# BARANGAROO DELIVERY AUTHORITY BARANGAROO HEADLAND PARK MARINE REPLY TO PLANNING SUBMISSIONS

**Report No** DD-HYD-S3-0904 Rev 1

**GENERAL ARRANGEMENT SITE PLAN**

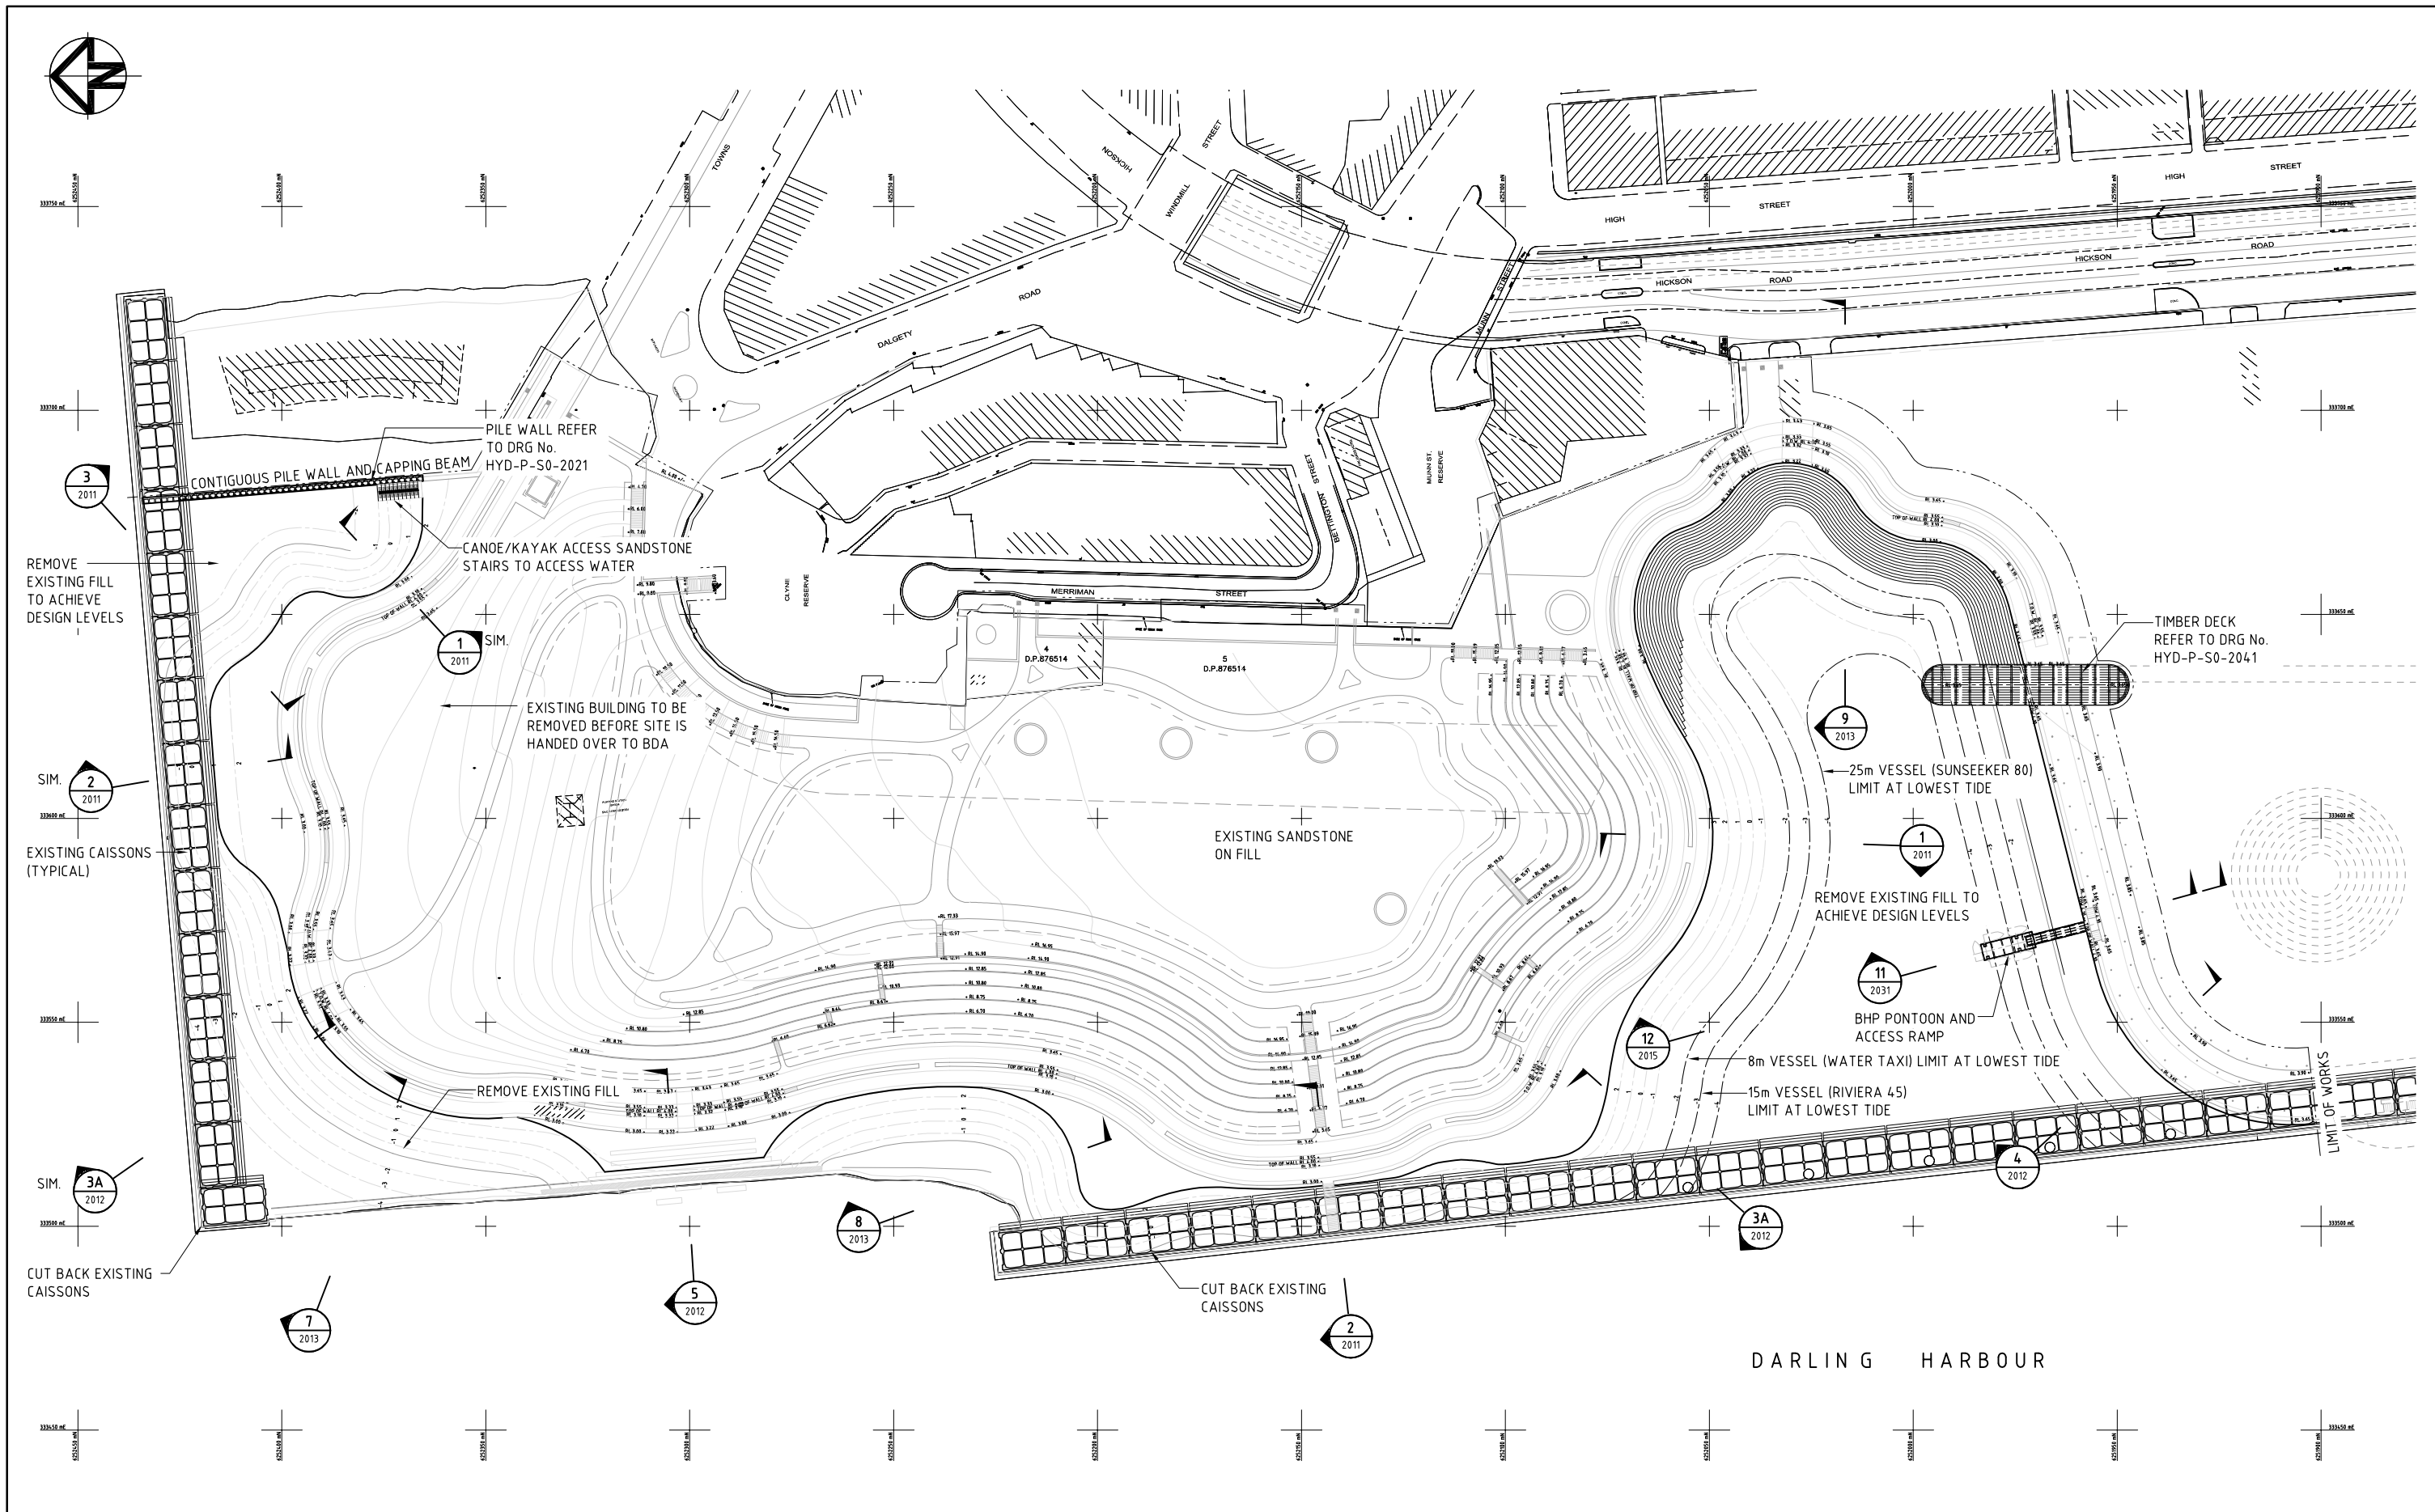
*“Concern over Northern Cove – based on the PA documentation considers that the depth of the Northern Cove is unclear. It would be preferable for it to be of sufficient depth to allow some navigation of area. Notes there is potential to provide further protection for the shoreline by building out part of the shoreline. Cutting the existing caissons to just below the tide level, rather than the bed level of the cove itself has the potential to create a significant navigation hazard and should be reconsidered.”*

The harbour floor of the Northern Cove is at AHD RL -4.00 which is equates to Zero Fort Denison Tide Gauge (ZFDTG), or Chart Datum (CD) or Lowest Astronomical Tide (LAT) or Indian Spring Low Water (ISLW) of RL-3.075. This will allow access for powered vessels up to 25 metres at all times. A cross section showing the depth of Northern Cove is shown on Hyder drawings HYD-P-S0-2015-B “Section Through North Cove” and HYD-P-S0-1011-B “General Arrangement Site Plan”.
